**LBP LEASING AND FINANCE CORPORATION  
(A LANDBANK Subsidiary)**

**SUPPLEMENTAL / BID BULLETIN NO. 01  
(LLFC-GAP-20-002)**

Issued pursuant to Section 22.5 of the Revised IRR of R.A. 9184, this Supplemental/Bid Bulletin is issued to modify and/or amend items in the issued Bidding Documents for the **Supply and Delivery of two (2) units Brand New 2020 6-Wheeler Truck with Customized Body (LLFC-GAP-20-002)**. This issuance shall be an integral part of the Bidding Documents:

**TOP VIEW**

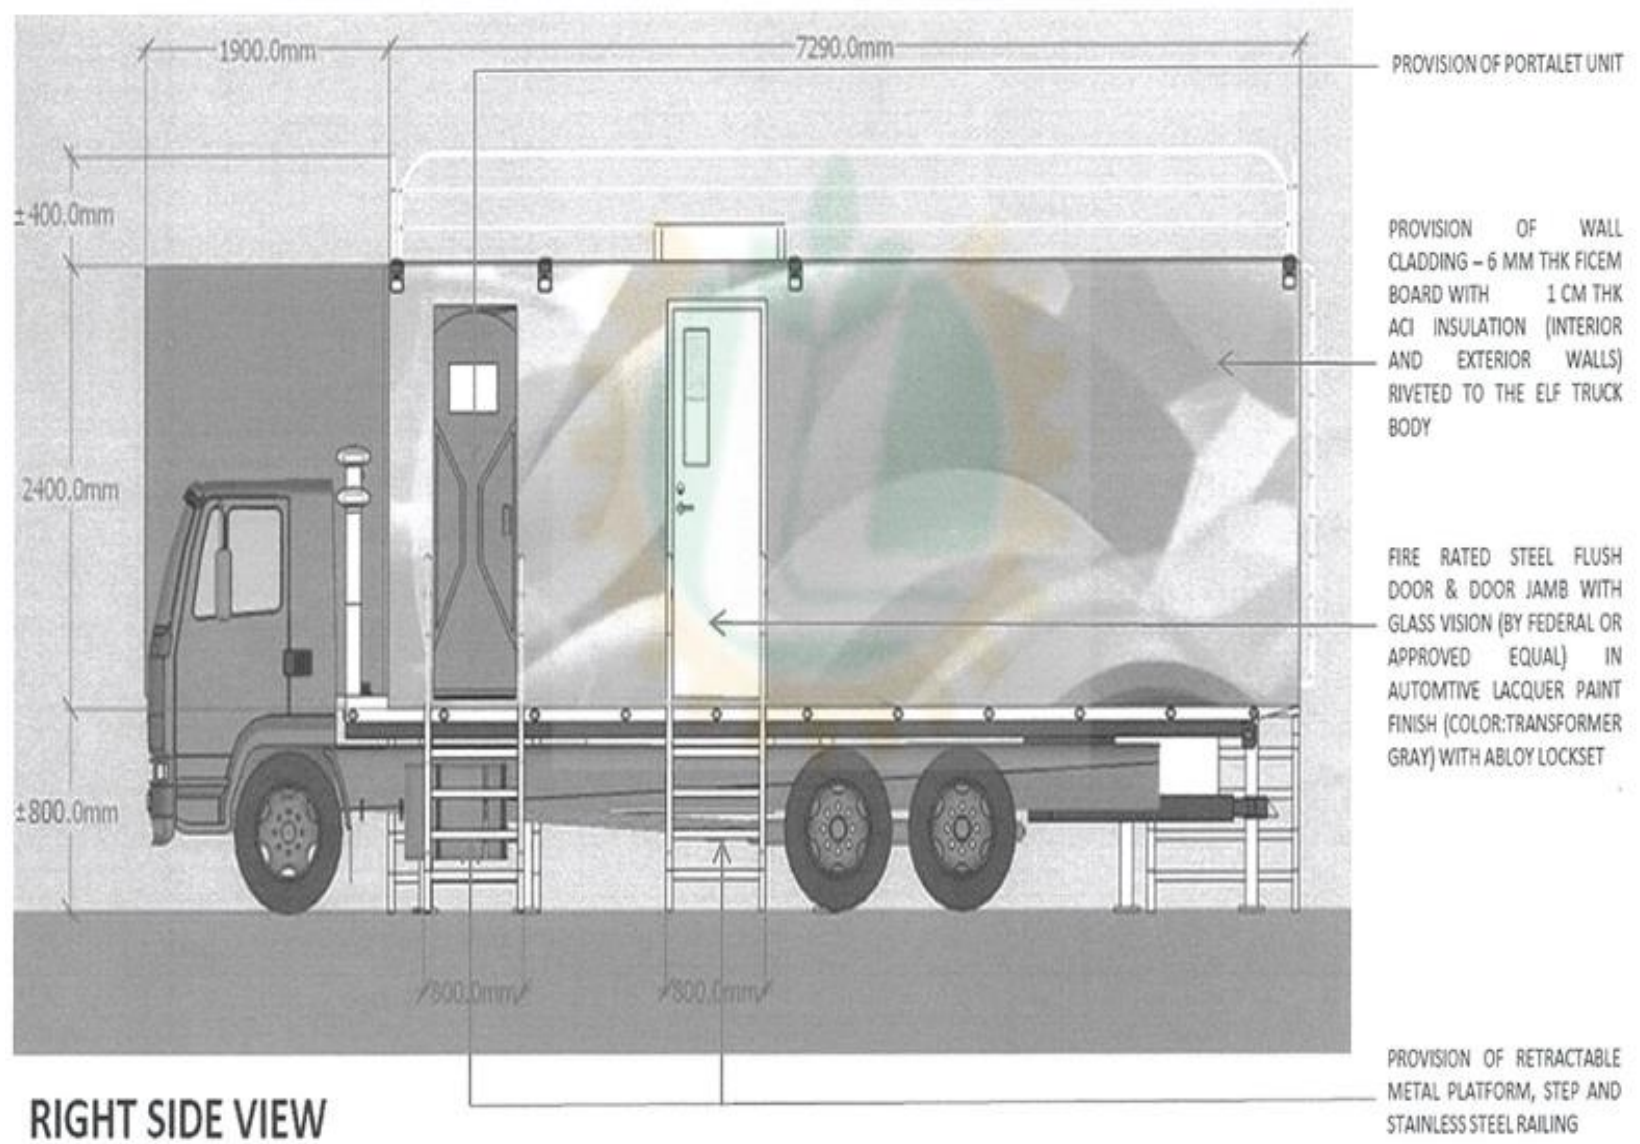
**G. Required Truck Design**

6mm THK ORDINARY GREEN  
FIXED GLASS PANEL ON 2mm  
THK x 50mm x 100mm BAKED  
POWDER COATED ALUMINUM  
FRAME (COLOR: TRANSFORMER  
GRAY) WITH SECURITY FILM

PROVISION OF FOLDABLE  
POLYCARBONATE CANOPY  
WITH HEAVY DUTY HINGES  
CONNECTED TO THE TRUCK  
BODY TOP HORIZONTAL  
FRAME

GA. 18 ALUMINUM LOUVERED  
DOOR PANEL ON GA. 16 50mm  
X 75mm BAKED POWDER  
COATED SINGLE REBBET JAMB  
WITH STAINLESS BARREL BOLT  
AND STAINLESS STEEL HANDLE  
(COLOR: TRANSFORMER GRAY)  
COMPLETE WITH ACCESSORIES

PROVISION OF RETRACTABLE  
METAL PLATFORM, STEP AND  
STAINLESS STEEL RAILING

**FRONT VIEW**

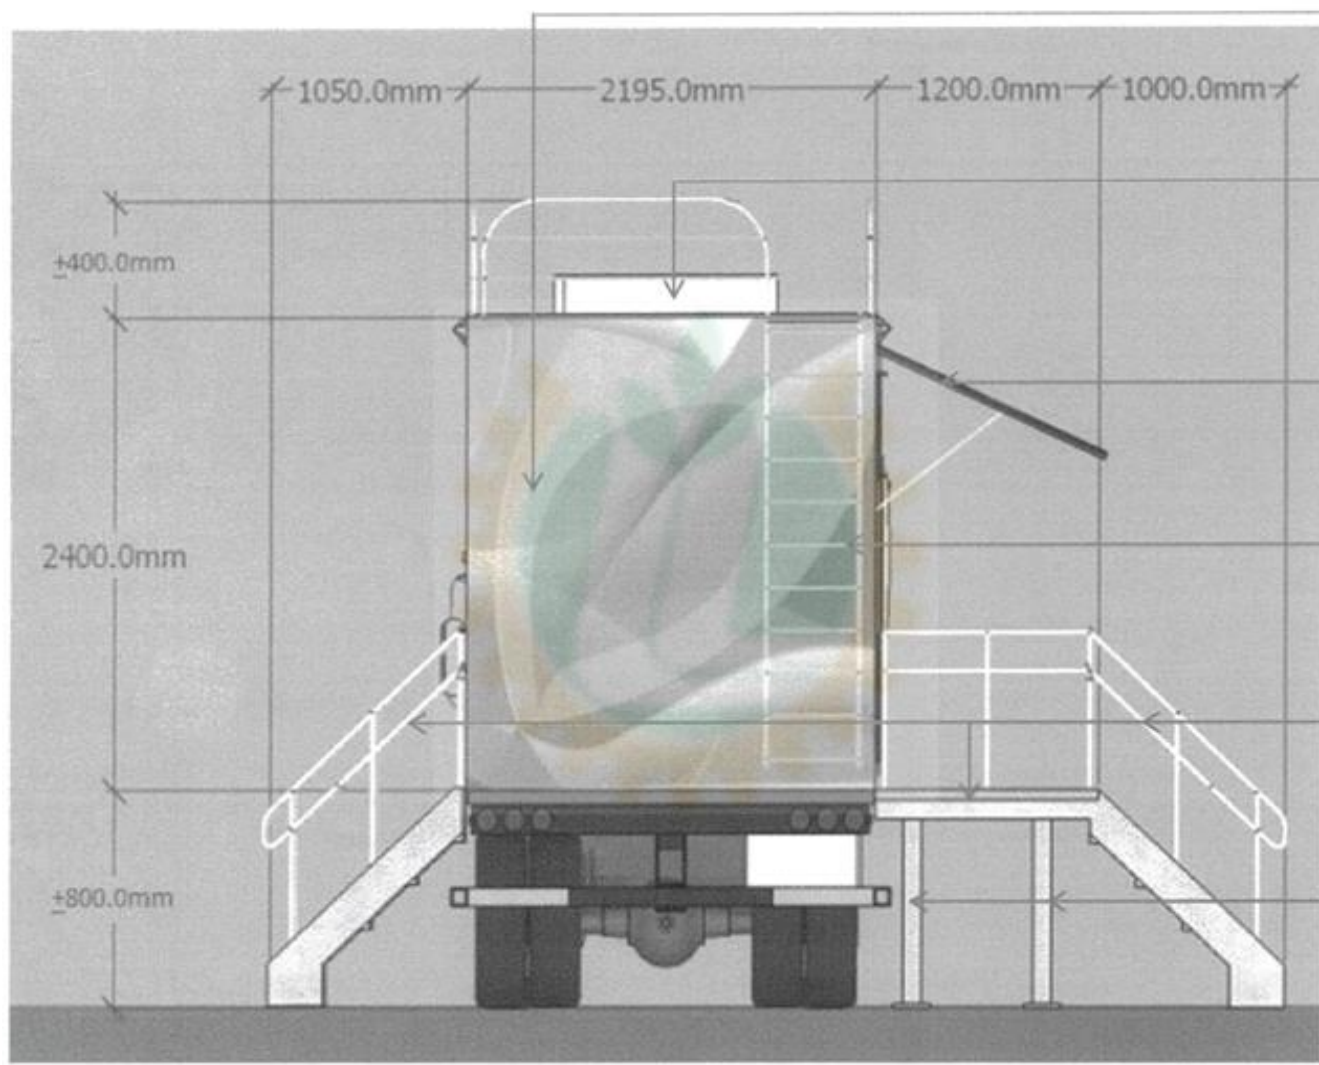
PROVISION OF WALL CLADDING – 6 MM THK FICEM BOARD WITH 1 CM THK ACI INSULATION (INTERIOR AND EXTERIOR WALLS) RIVETED TO THE CONTAINER VAN BODY

AIR - CONDITIONING UNIT (ROOF MOUNTED TYPE)

PROVISION OF FOLDABLE POLYCARBONATE CANOPY WITH HEAVY DUTY HINGES CONNECTED TO THE TRUCK BODY TOP HORIZONTAL FRAME

HEAVY DUTY ALUMINUM LADDER AND RAILING

PROVISION OF RETRACTABLE METAL PLATFORM, STEP AND STAINLESS STEEL RAILING

4 – UNITS HYDRAULIC TRUCK STAND PIN

**REAR VIEW**

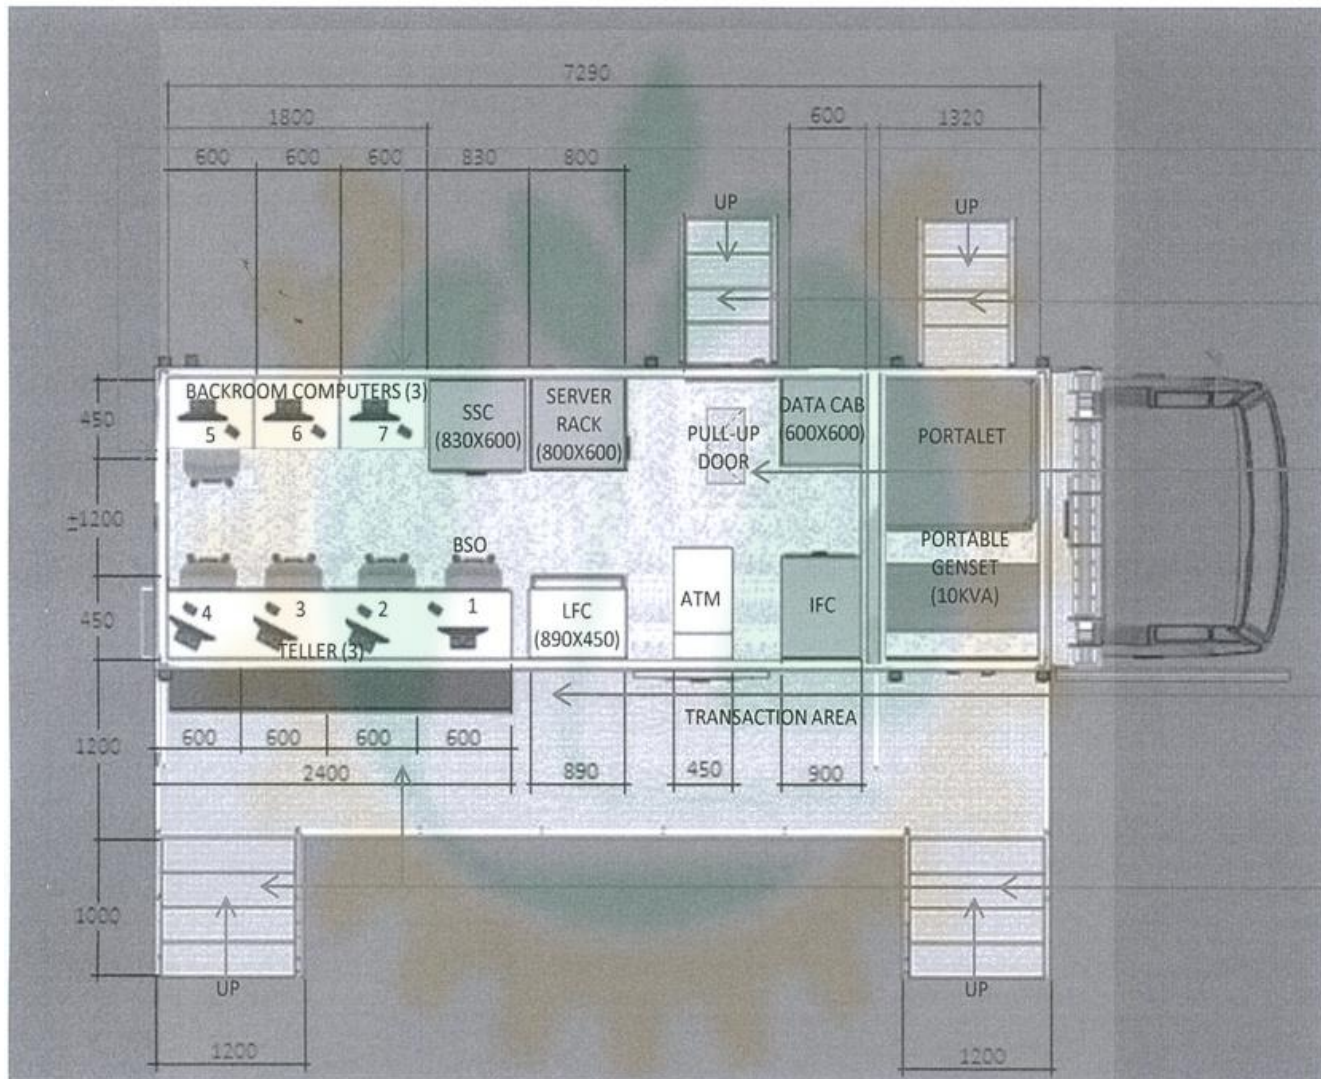
PROVISION OF WALL CLADDING – 6 MM THK FICEM BOARD WITH 1 CM THK ACI INSULATION (INTERIOR AND EXTERIOR WALLS) RIVETED TO THE CONTAINER VAN BODY

PROVISION OF RETRACTABLE METAL PLATFORM, STEP AND STAINLESS STEEL RAILING

.20m X .30m X 1.30m PULL UP DOOR

PROVISION OF FOLDABLE MARINE PLYWOOD COUNTER (HIGH PRESSURE LAMINATE)

PROVISION OF RETRACTABLE METAL STEP AND STAINLESS STEEL RAILING
